Rock Hill Board of Historic Review

Regular Public Hearing
September 2, 2021
6:00 p.m.

A G E N D A

PLAN OF EXISTING COVERED PORTICO

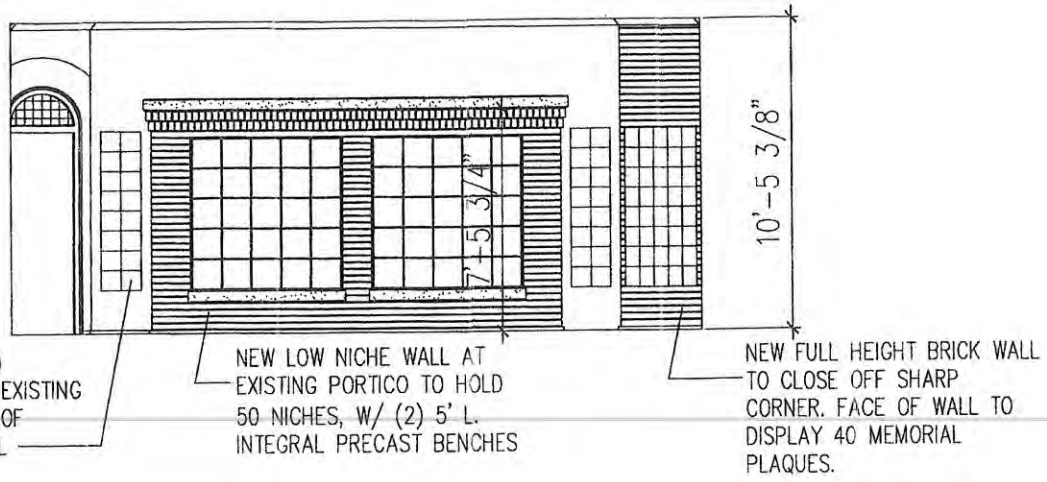
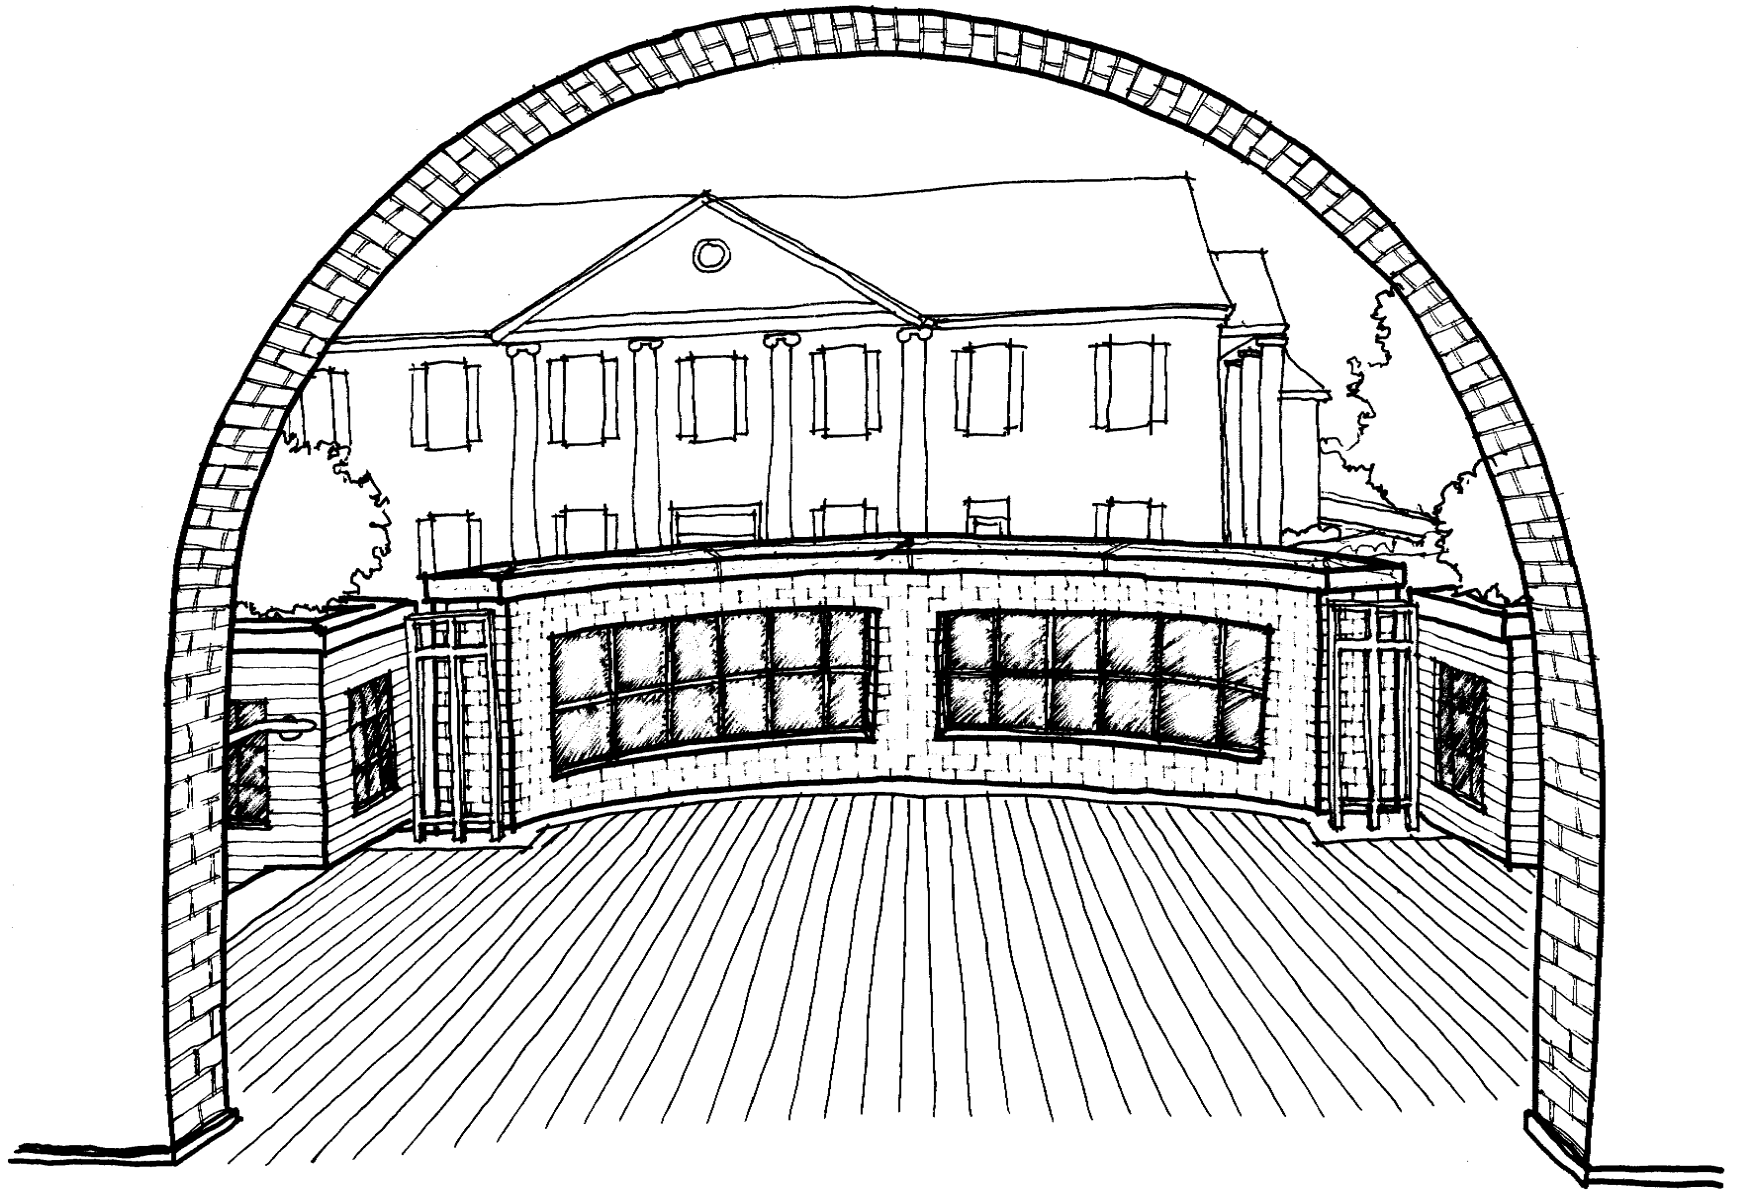
The proposed change will have a slight effect on the exterior appearance of the primary façade as one wall in the portico portion of the main building will be fitted with a columbarium structure and the iron railing on both terrace areas will be replaced with columbarium structures proposed to face the interior.

Staff recommends approval of the request to construct the columbarium structures as proposed.

- the columbarium located in the portico area will be located closer to the wall of the main building and will therefore not be readily visible;

- the columbarium structure on the terrace areas will face the church building; and
 - the location is more sacred and private than any other location on the site.
-

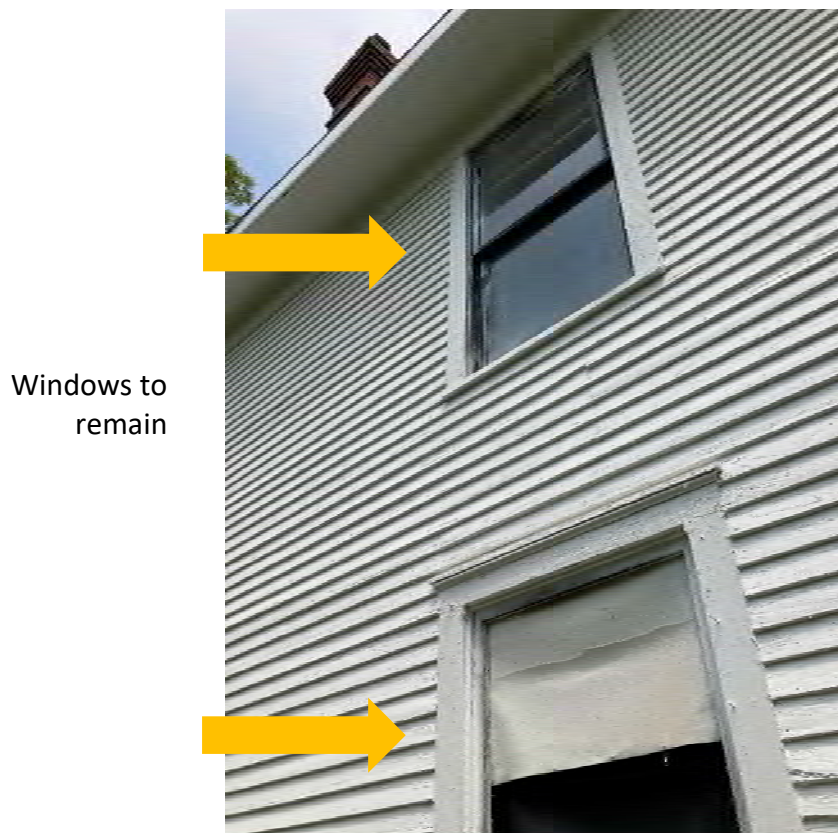
The applicant has agreed to repair those windows located on the front façade and the top and bottom windows to either side of the front porch. Several of the original windows with missing sashes are proposed to be repaired using parts from matching windows, if approved for replacement. Other than the one-over-one sash configuration, the windows do not have any distinctive details. The applicant would like to replace the six-over-six and six-over-one windows on the rear with one-over-one windows to match the rest of the structure.

Staff recommends approval of the request to install the gutters and to replace the windows as proposed with the conditions that the front façade windows and the top and bottom windows located on the secondary façade to either side of the front façade be repaired, that all replacement windows be of one-over-one sash configuration, and that all replacement windows match in dimensions.
